Service Bulletin

BULLETIN # 273

WELDARC 145I (MC106)

E-01 ERROR TOLERANCE ADJUSTMENT/REMOVAL

Figure 1 - 000 displayed

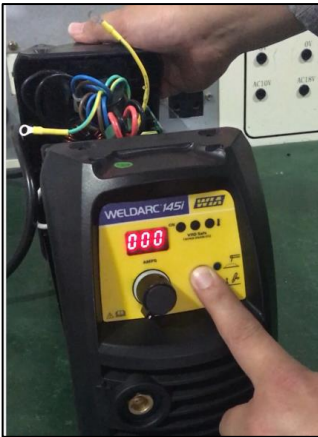
1. Adjust the machine to minimum current.
2. Connect the machine to mains power – Do not switch on.
3. Press and hold the mode select button, at the same time apply power to the machine using the power switch.
4. Continue to hold the mode select button until “CH” and then “000” appears on the display (Figure 1).
